## LiDAR Quality Assessment Report

### SD\_Missouri River Lidar Dewberry\_2016\_D16 - Block 8

NGTOC  
2018-06-18  
Sarah Klaas

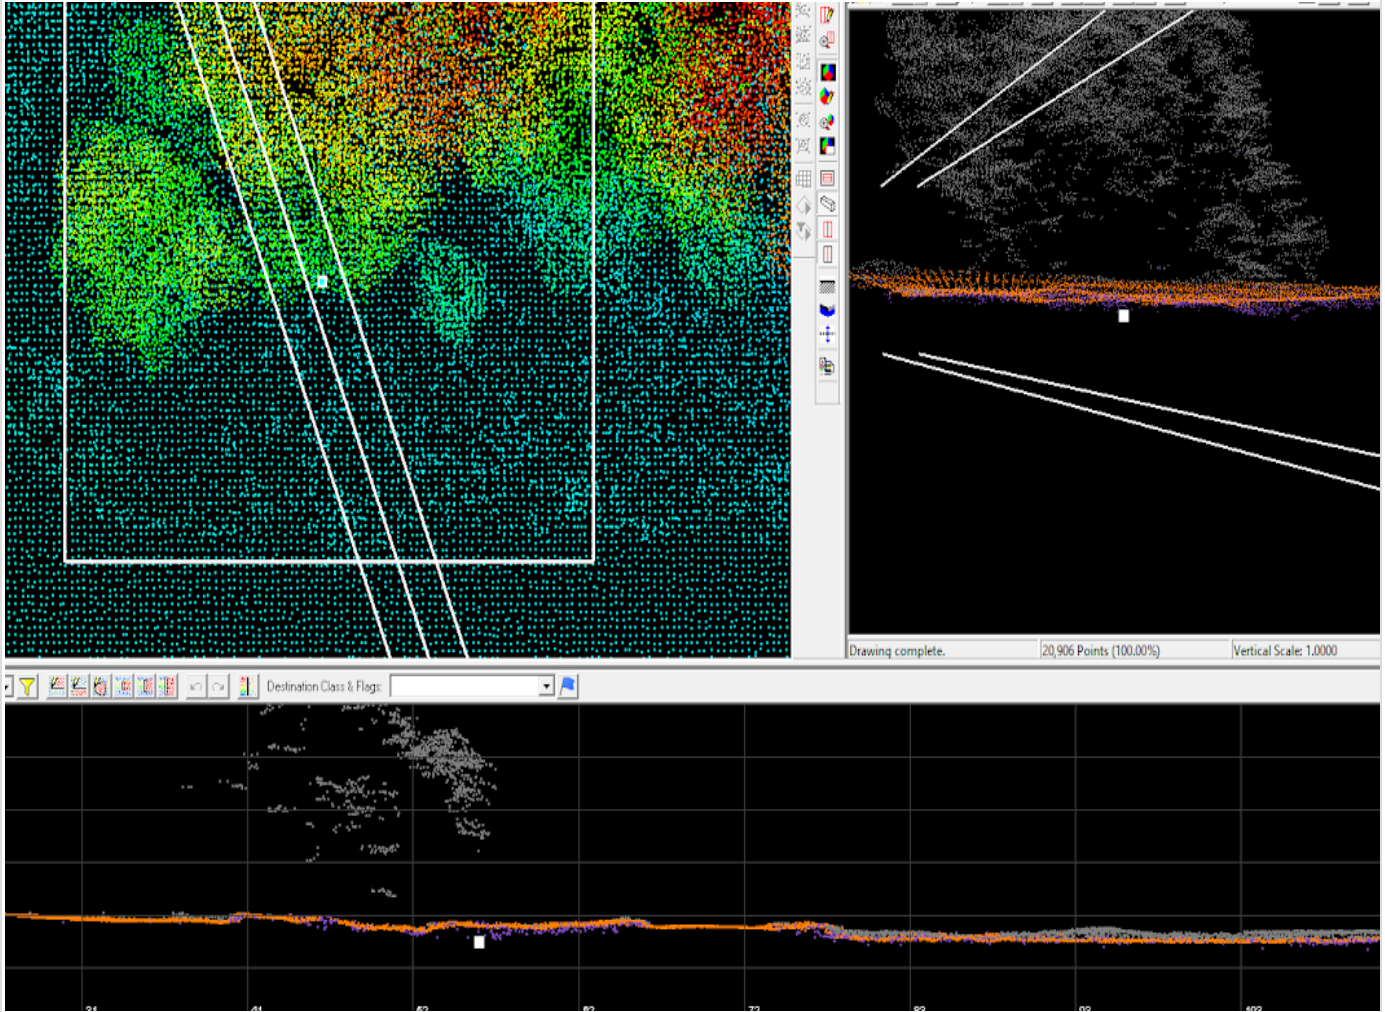
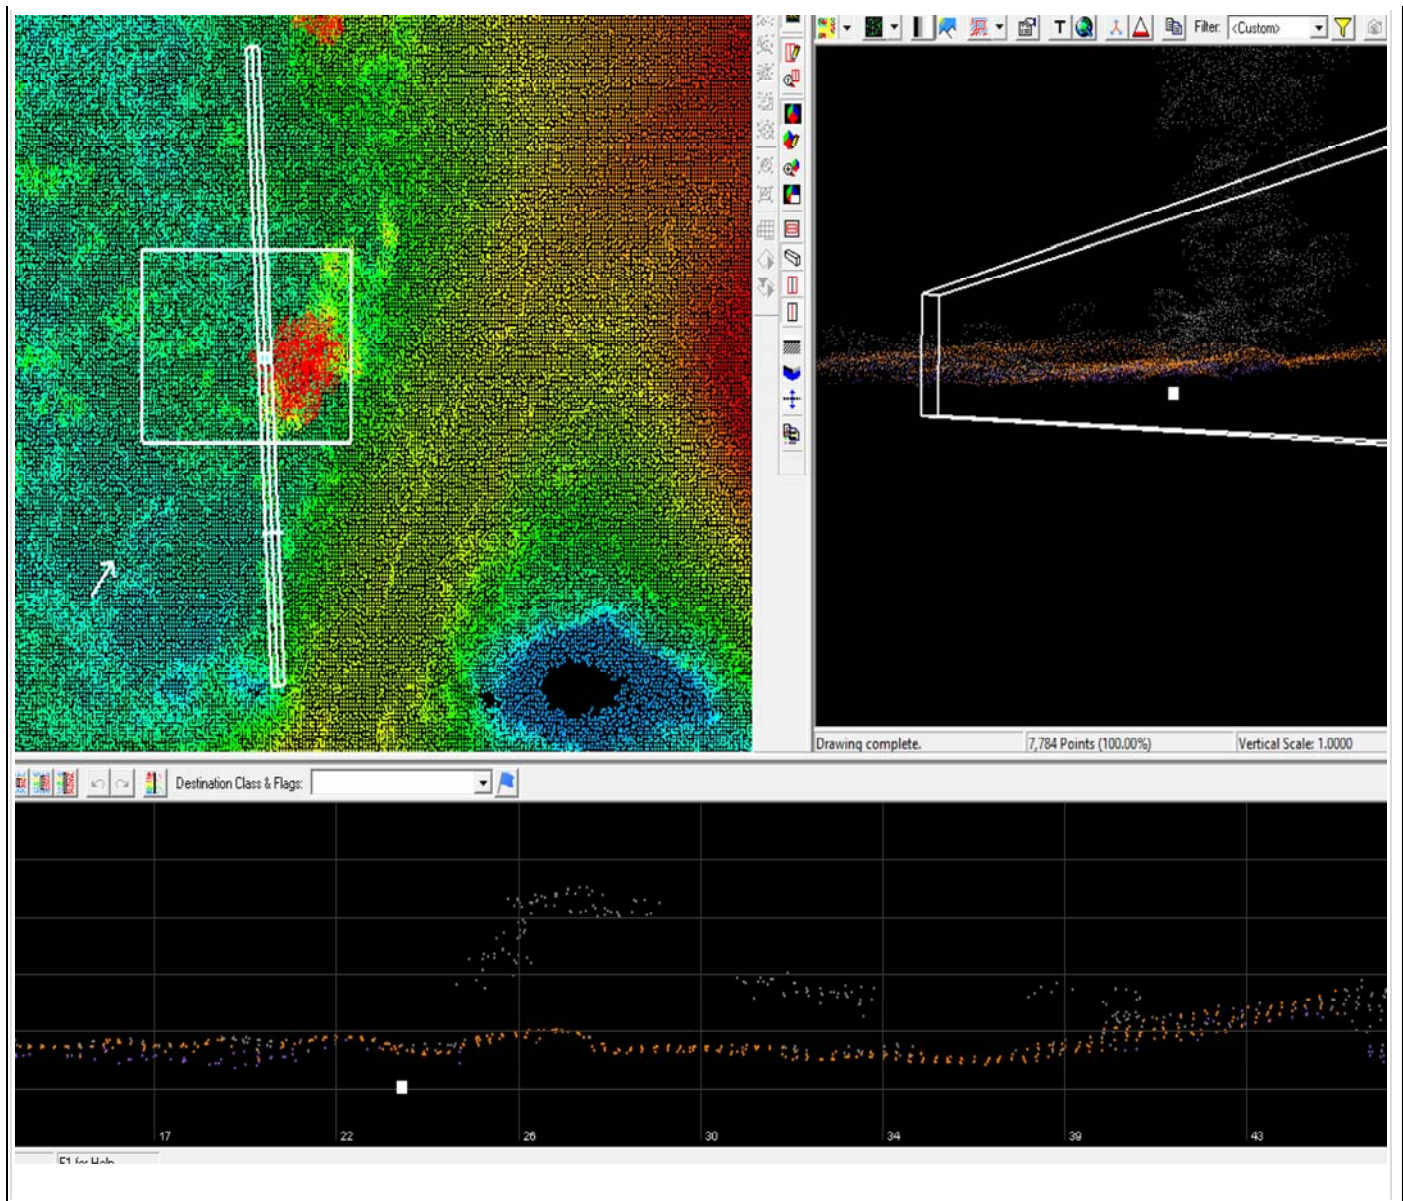
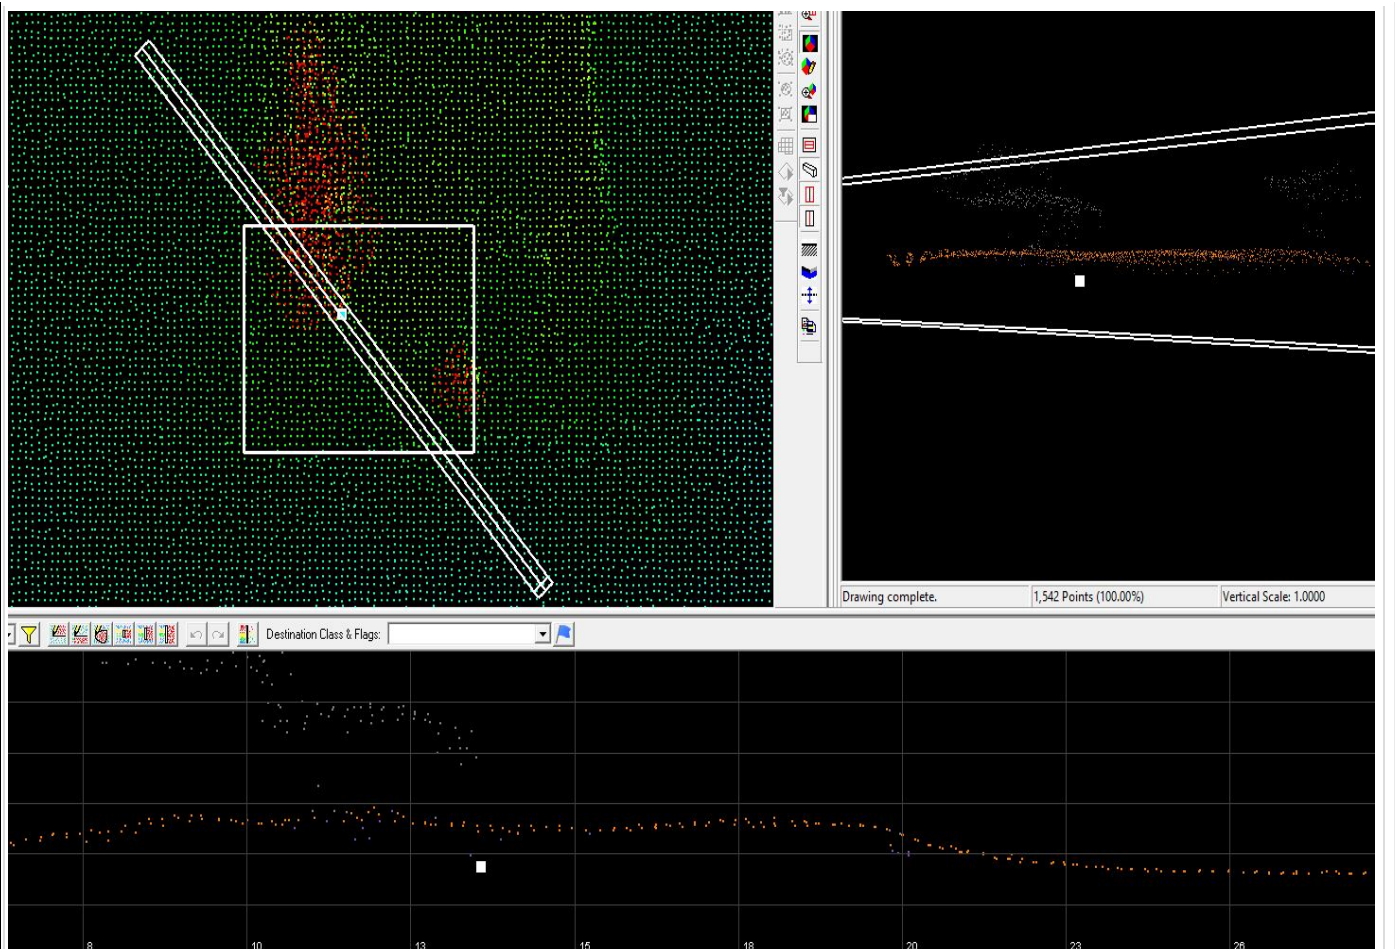
VVA testing failed to meet USGS specifications. Three of the worst points are pictured below, showing the checkpoint below the ground surface.

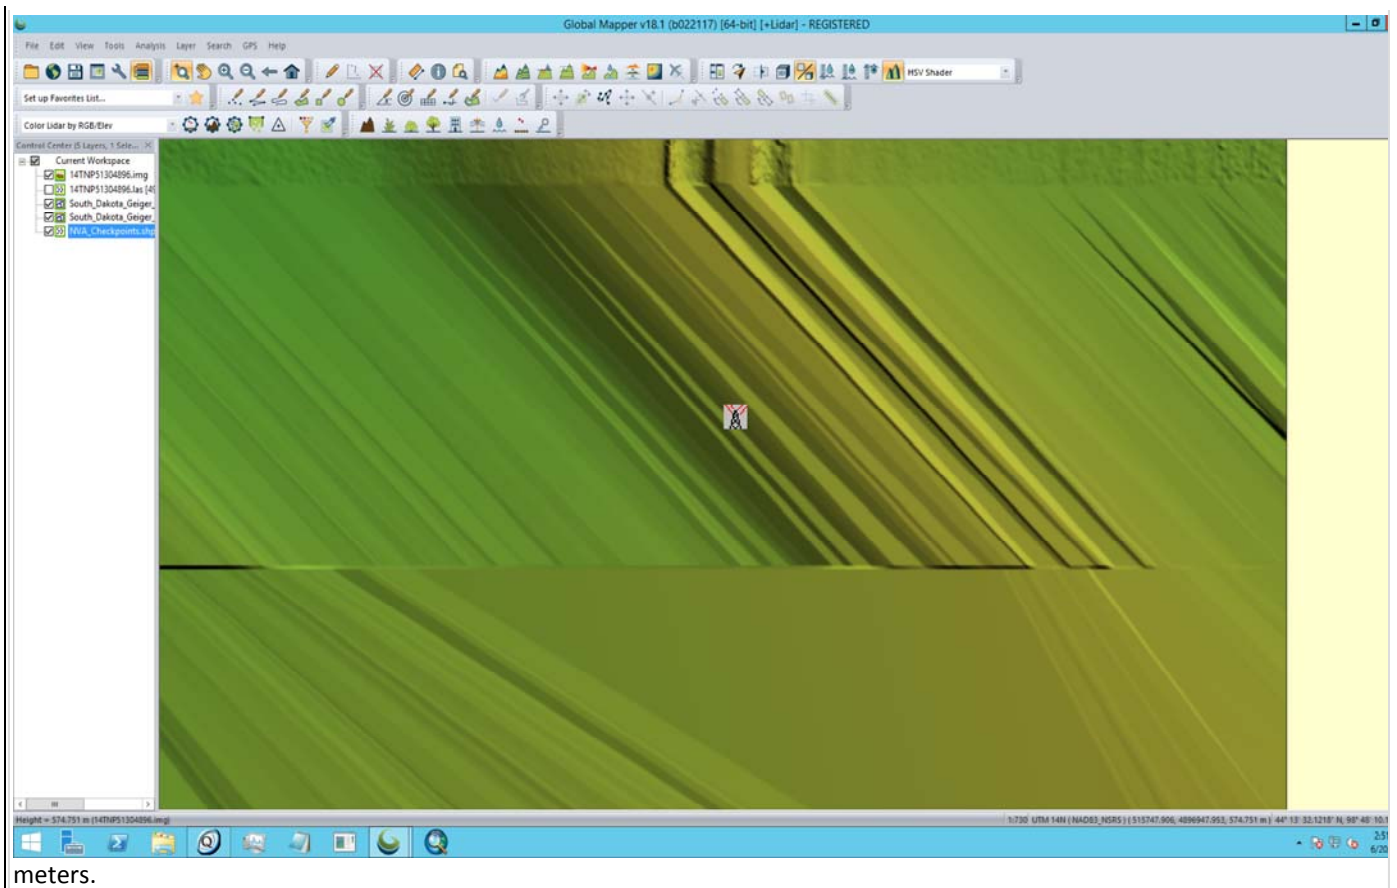
**NVA point 171 was removed from DEM vertical testing. It was found that this point was in an area of data void which was causing a dz value of -1.**

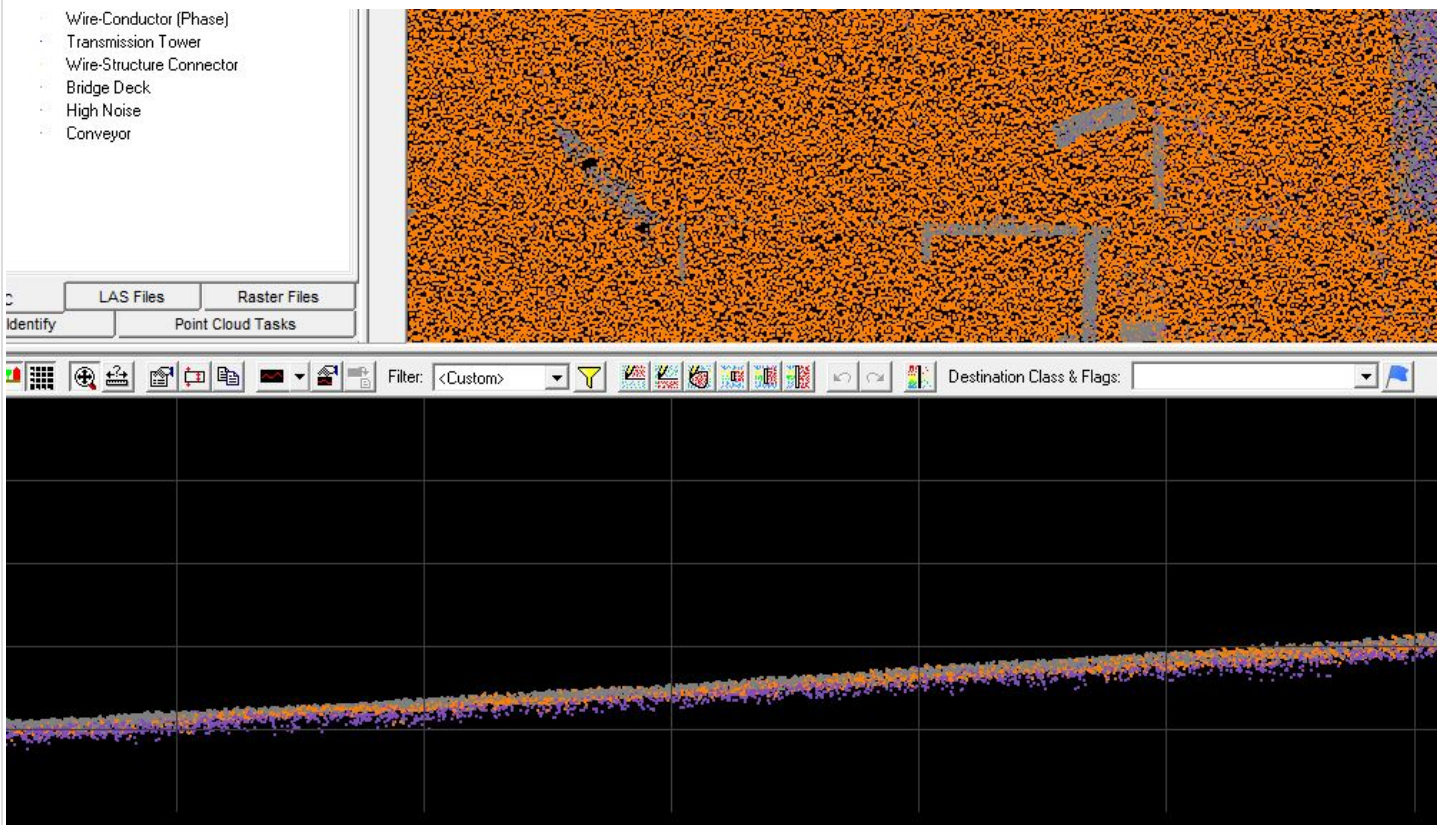
Global Encoder is set to 17

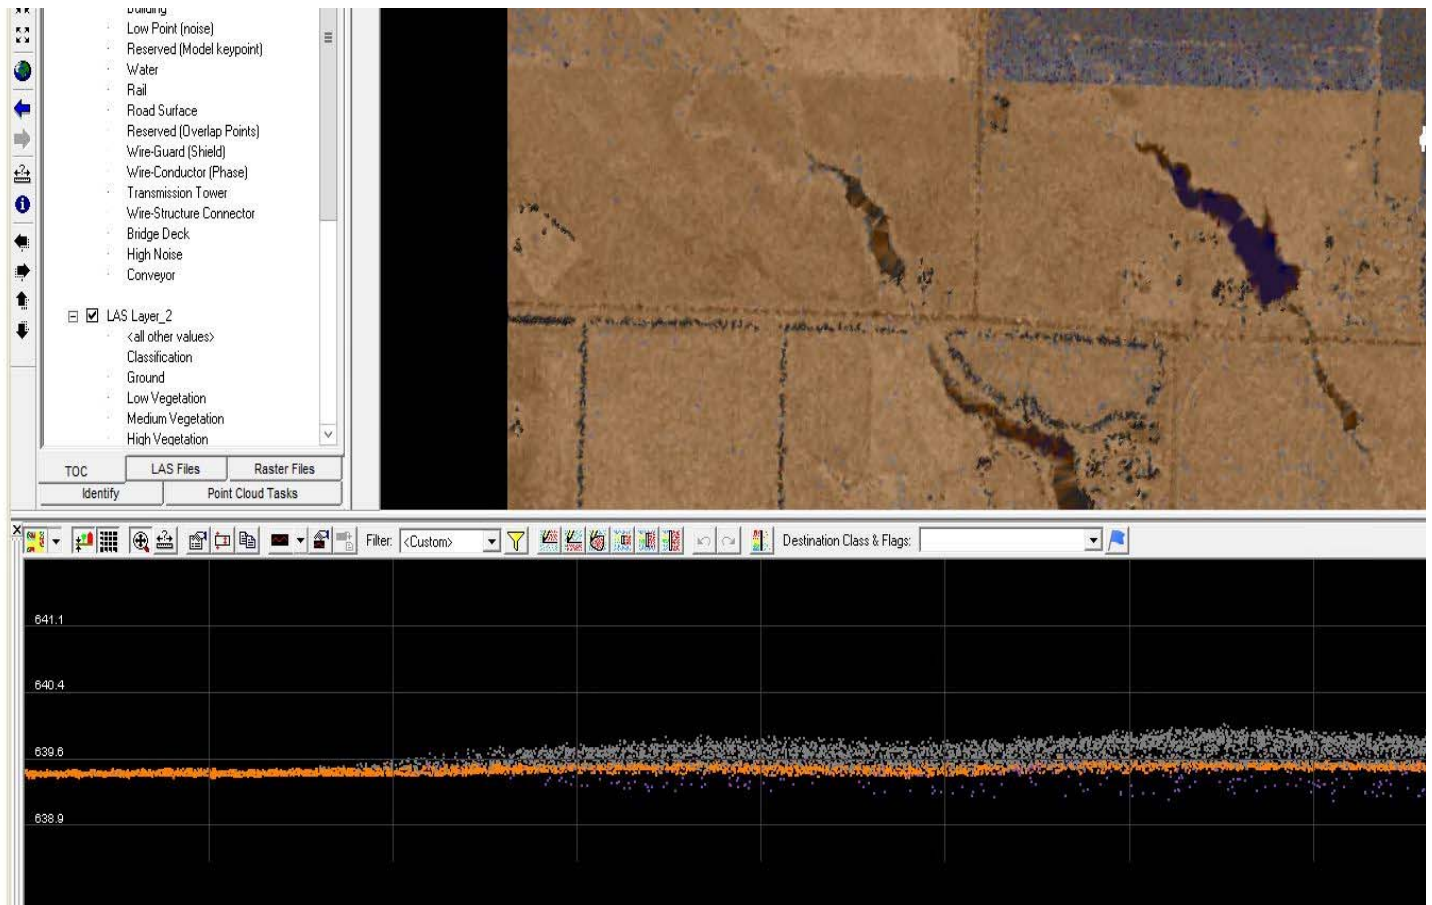
Noise and ground points in an agricultural field with probable vegetation. (6/18/18)
